## SYNCHRONOUS BELT DRIVE SYSTEM TECHNICAL SERVICE BULLETIN

### BULLETIN PA007-11

### INSTALLATION RECOMMENDATIONS FOR TIMING BELT SYSTEM ON HONDA 1.7L ENGINES

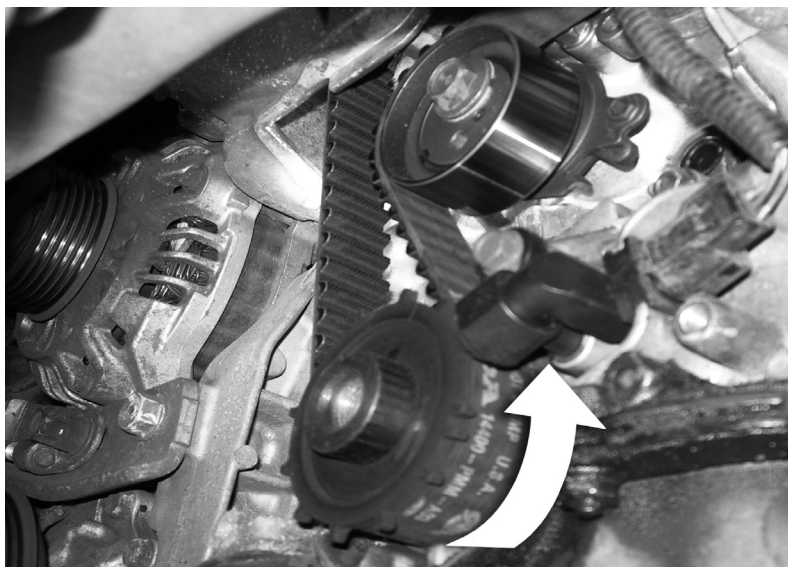
Below is the result from improper belt setup. Notice the damaged spring, this is the result of turning the crankshaft clockwise during initial setup, which is incorrect.

During setup attention needs to be given to the relationship of tensioner spring. The spring must be in the "UP" position which is noted on the spring rubber dampener.

See installation instructions provided in this kit. Crankshaft must be rotated two turns **COUNTERCLOCKWISE** with locking pin in tensioner and attachment bolt loose.
